Killearn Road Improvements Project – Town of Washington Planning Board Comments #002 with Responses

Project No.: 25006179G

Email: <u>daniel.farnan@collierseng.com</u> **Project Name:** Killearn Road Final Design and Permitting

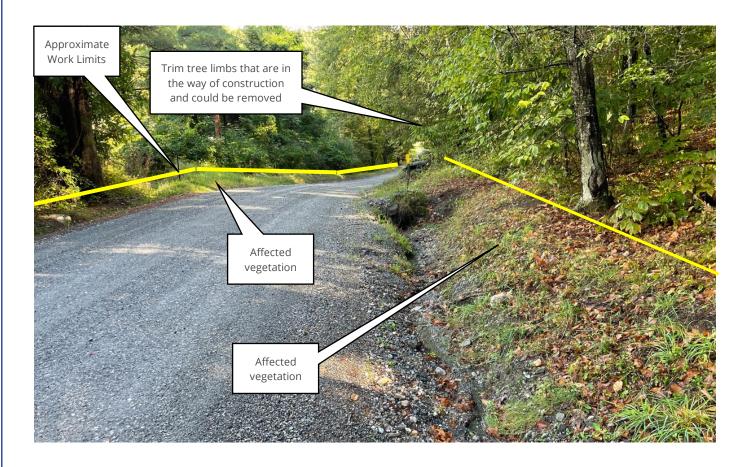
Finally, as noted in Mr. Marino's memo, the maps or Plans should supply more information on where the wetlands disturbances will occur and what type of protection will be provided. Although the Applications state that less than 125 sq ft of wetlands will be disturbed, we note the presence of wetlands along much of Killearn Road, so we wonder how the impact will be so limited. We also note that the Plans are in draft form, and we wonder what if any changes may be forthcoming.

CED Response: The June 16, 2025, set of plans show both areas of wetland disturbance. The first is on sheet 14 of 28 and the second on sheet 17 of 28. A new sheet will be added to the plan set that shows only these two areas on one sheet, zoomed in for clarity.

Yes, the project plans will be finalized after the Town Board and CED enter a contract phase for Construction. Plan changes will include at a minimum: Addressing all comments from the Planning Board process received to date, which exceed our current contract for initial Planning Board Application, incorporating any changes from the Town's surveyor or record (if any), any permit conditions from both the Planning Board Wetlands Permit and future submittals to the USACE/DEC permitting process that need to be listed on plans for bidding purposes, specifications from the Highway Superintendent on Stone Topping discussed at the beginning of this letter, any further comments from the Public Hearing if it remains open at the next Planning Board Meeting, and stamping/signatures on plans.

Vegetation Clearing Examples:

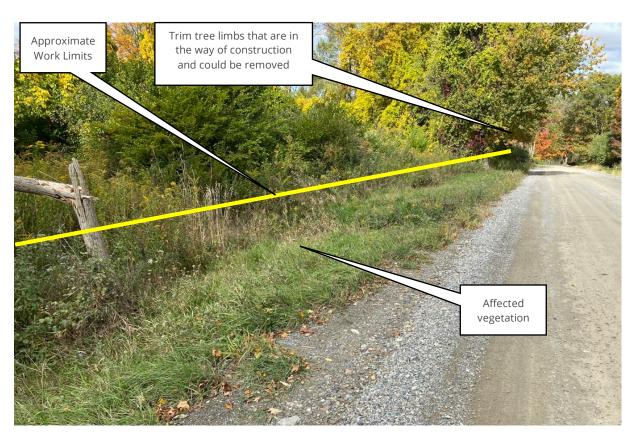
The second area relates to the clearing of 0.7 acres of roadside vegetation, as noted on the EAF. The planning Board should obtain more information regarding where the clearing will occur and whether the clearing is necessary, as also noted in the AKRF Memo.

CED Response: As discussed with AKRF at the July 1st Planning Board meeting, the tree line depicted on our plans comes from the Town's surveyor or record – CT Male Associates – and does not discern what type of vegetation is present. Based on several site visits, most roadside vegetation to be cleared is grass and overgrowth within the Highway Boundary (Right of Way). Mature trees are to be avoided and notes pertaining to vegetation protection will be added to plans, as stated in other comments above. We would also like to note that no vegetation clearing beyond the Highway Boundary (Right of Way) is proposed.

At the end of this letter, CED has assembled some pictures of roadside areas that illustrate intent for vegetation clearing.

Below are two typical examples of vegetation that could be affected by work limits. As described above, it is the design intent to avoid mature trees and only remove grass, brush, and tree limbs within or overhanging work limits.
